## Addendum No. 1

**Project Number:** 23-153-01

**Project:** **Montana Fish, Wildlife, & Parks**  
Montana Outdoor Office Remodel  
930 Custer Avenue, Helena, Mt 59602

**1 NEW LIGHTING PLAN**  
 1/4"=1'-0"

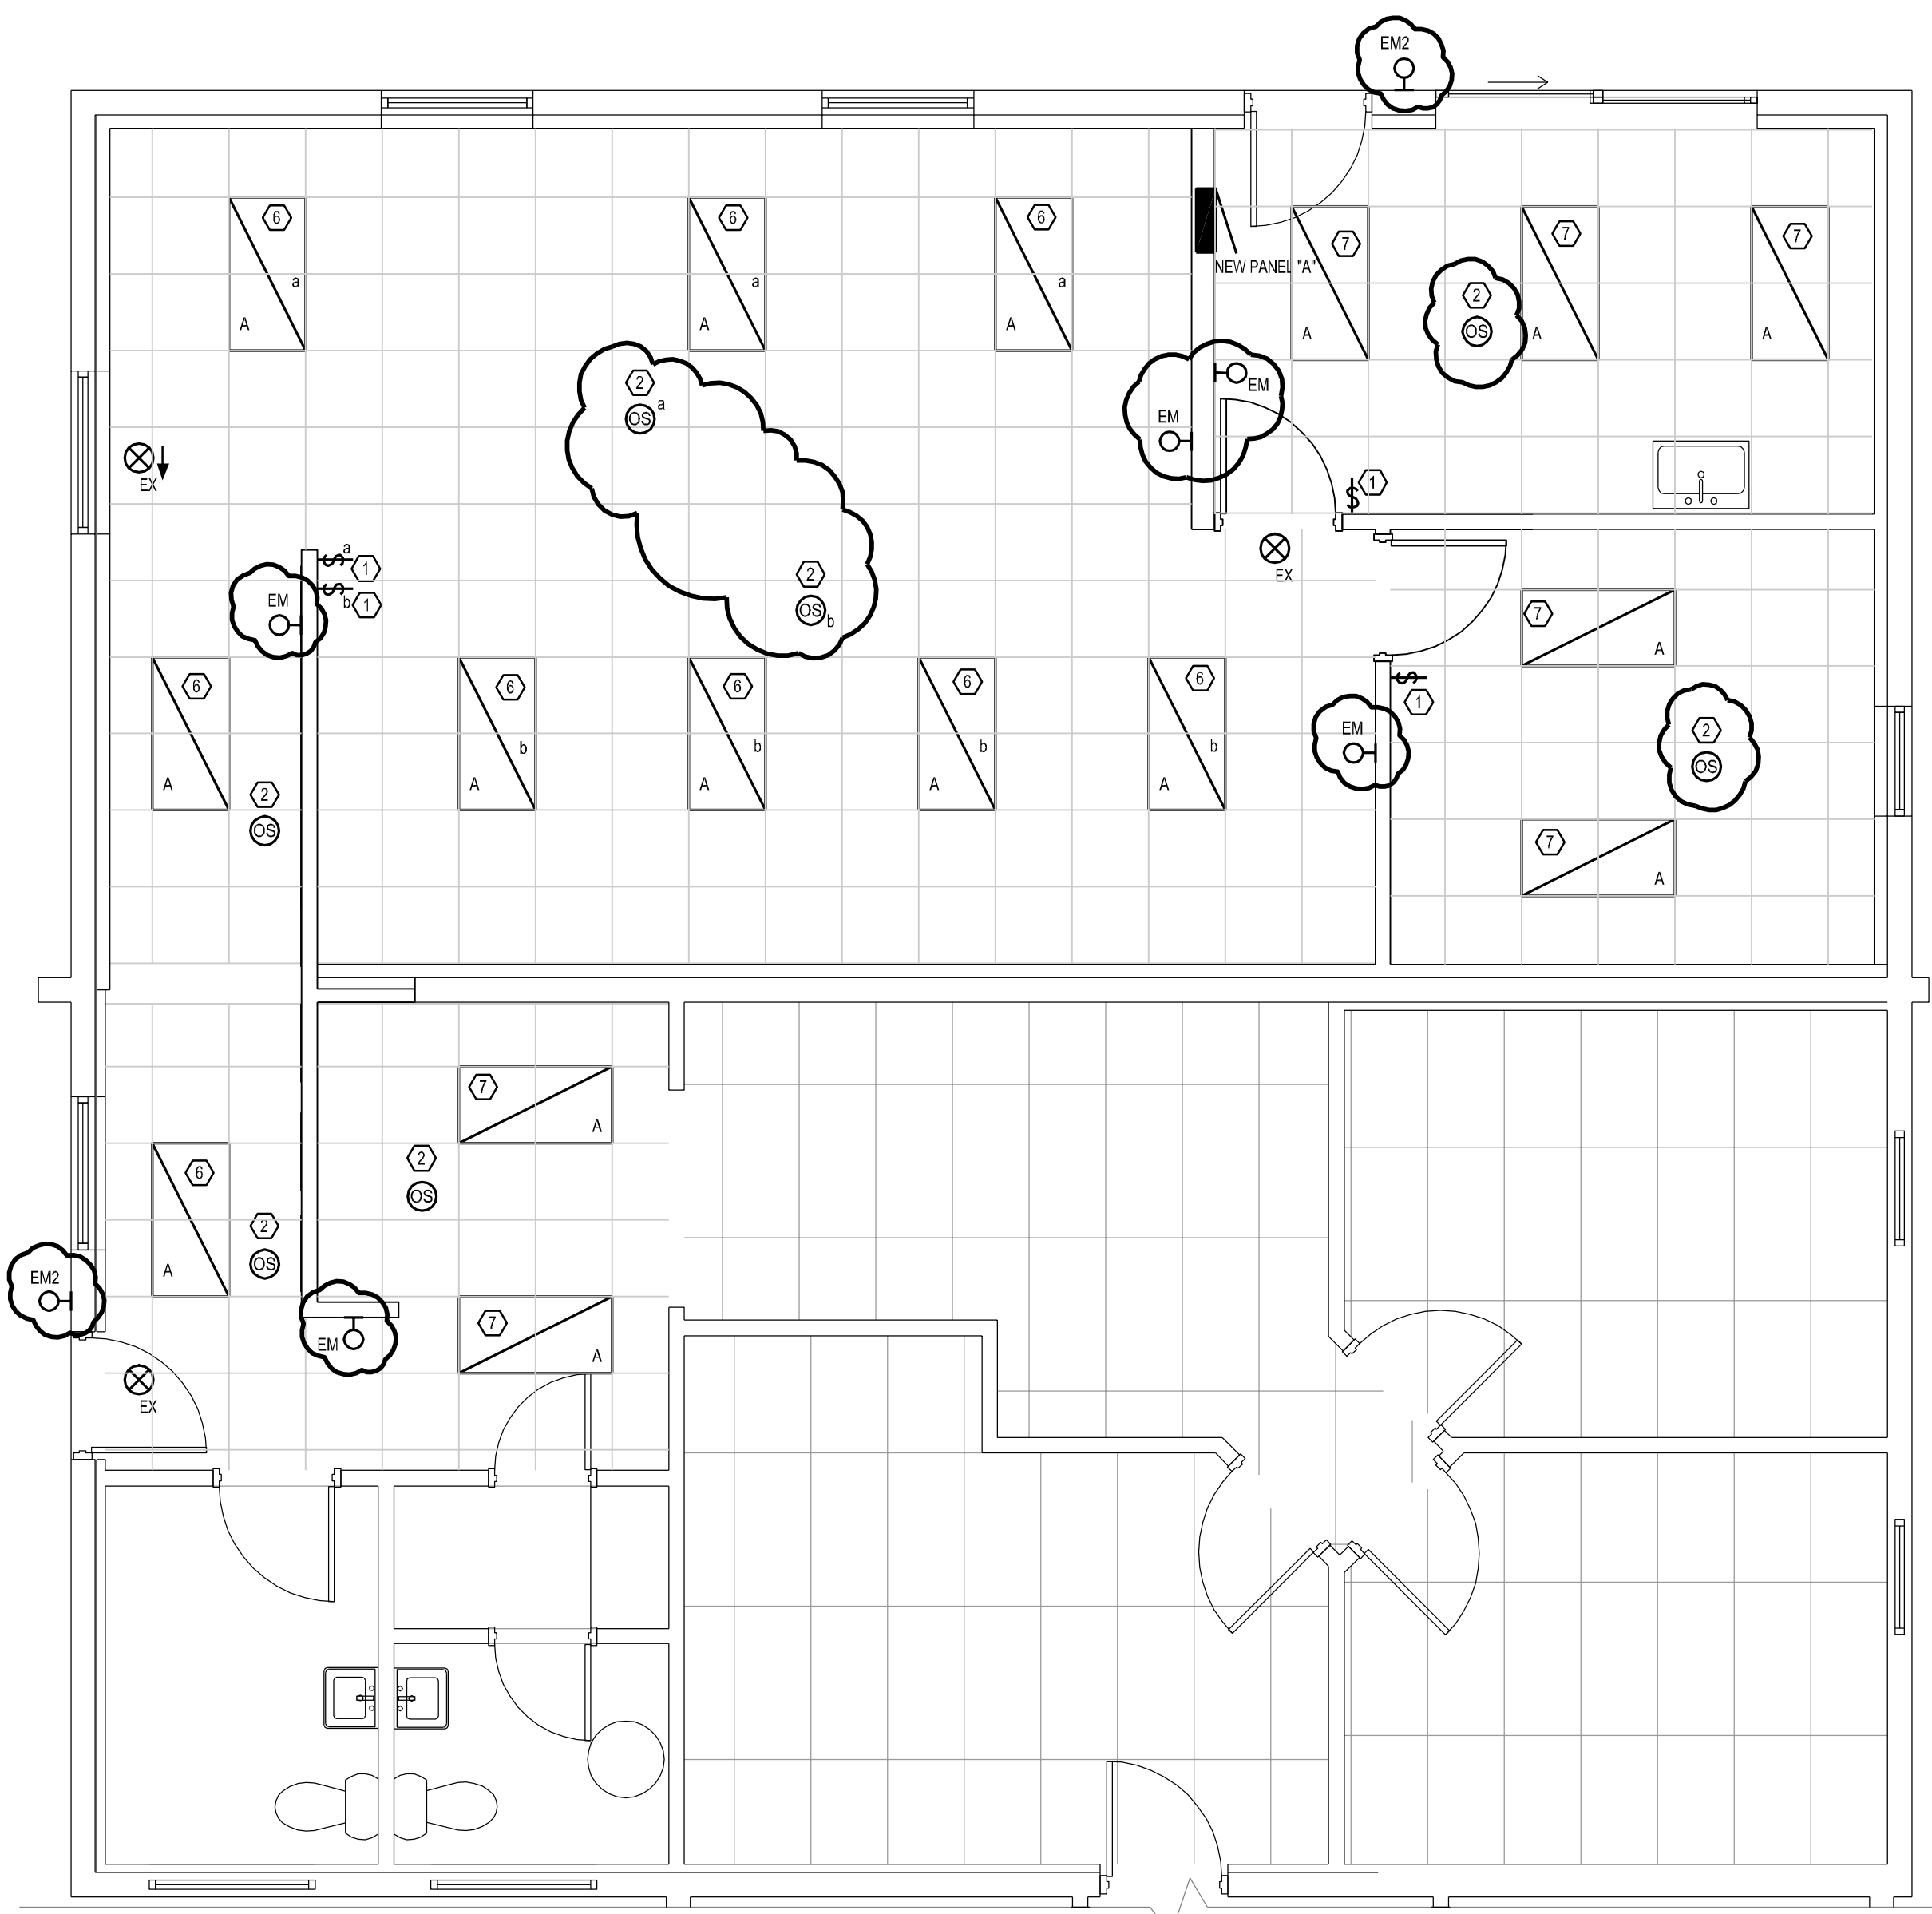
- ITEM E-1 SHEET E1.2R LIGHTING AND POWER\LOW VOLTAGE PLANS, AND SCHEDULES:** Occupancy sensors will be required in the following rooms: Entry 101, Open Office 103, Breakroom 104, Office 105. See re-issued electrical sheet E1.2R.

- ITEM E-2 SHEET E1.2R LIGHTING AND POWER\LOW VOLTAGE PLANS, AND SCHEDULES:** Add emergency lighting fixtures. See re-issued electrical sheet E1.2R.
- ITEM E-3 SHEET E1.2R LIGHTING AND POWER\LOW VOLTAGE PLANS, AND SCHEDULES:** Delete construction note #5 and replace with the follow: "Provide power feeds to office furniture through wall or ceiling as required. Verify requirements with supplier". See re-issued electrical sheet E1.2R.

2. PROVIDE CEILING MOUNTED OCC SENSOR, LUTRON OR EQUAL, WITH 30 MIN. DELAY. CONNECT TO FIXTURES IN ROOM AS INDICATED/REQUIRED.  
 3. PROVIDE RECEPTACLE IN EXISTING WALL FOR MICROWAVE. VERIFY HEIGHT WITH USERS. FISH MC CABLE IN WALL TO MICROWAVE HEIGHT, +07' AFF.

**2 NEW POWER/LOW VOLTAGE PLAN**  
 1/4"=1'-0"

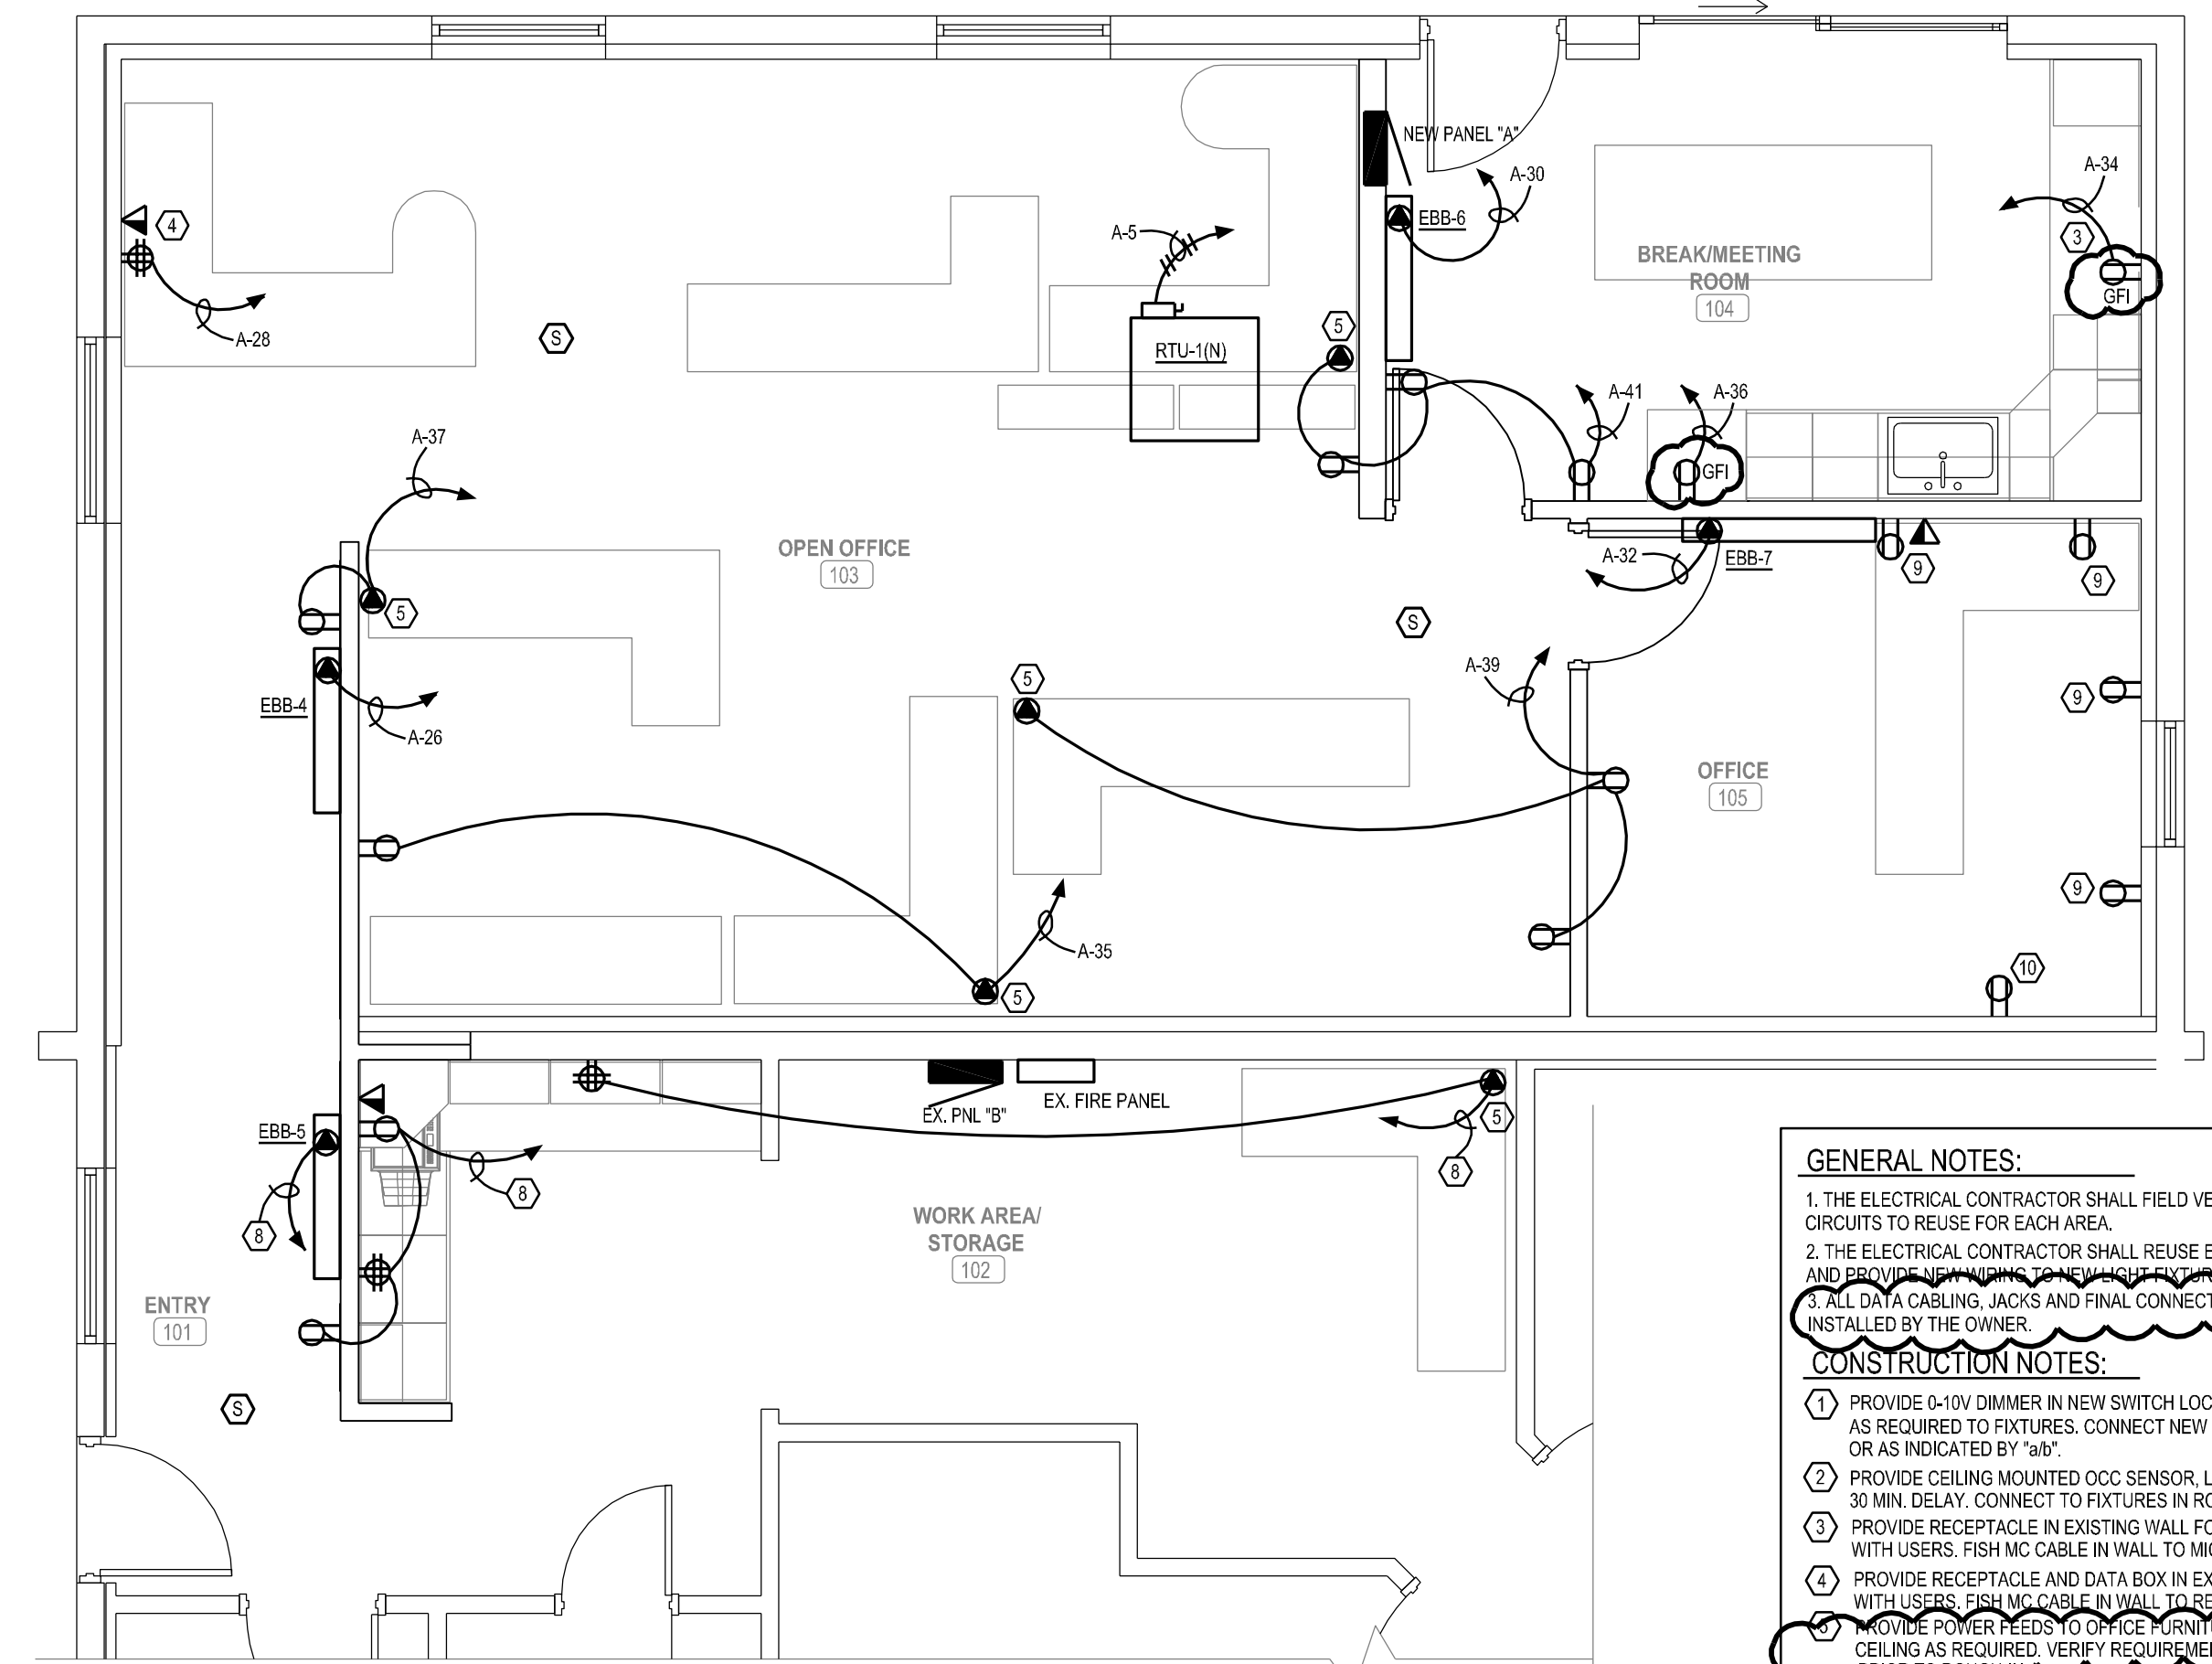
- ITEM E-3 SHEET E1.2R LIGHTING AND POWER\LOW VOLTAGE PLANS, AND SCHEDULES:** Add general note #3: "Add general note as follows: All data cabling, jacks and final connections will be supplied and installed by the owner. See re-issued electrical sheet E1.2R.

3. ALL DATA CABLING, JACKS AND FINAL CONNECTIONS WILL BE SUPPLIED AND INSTALLED BY THE OWNER.  
**CONSTRUCTION NOTES:**  
 1. PROVIDE 0-10V DIMMER IN NEW SWITCH LOCATION. PROVIDE NEW WIRING AS REQUIRED TO FIXTURES. CONNECT NEW SWITCHES TO FIXTURES IN ROOM OR AS INDICATED BY "AS".

4. PROVIDE RECEPTACLE AND DATA BOX IN EXISTING WALL. VERIFY HEIGHT WITH USERS. FISH MC CABLE IN WALL TO RECEPTACLE HEIGHT.  
 5. PROVIDE POWER FEEDS TO OFFICE FURNITURE THROUGH WALL OR CEILING AS REQUIRED. VERIFY REQUIREMENTS WITH SUPPLIER.
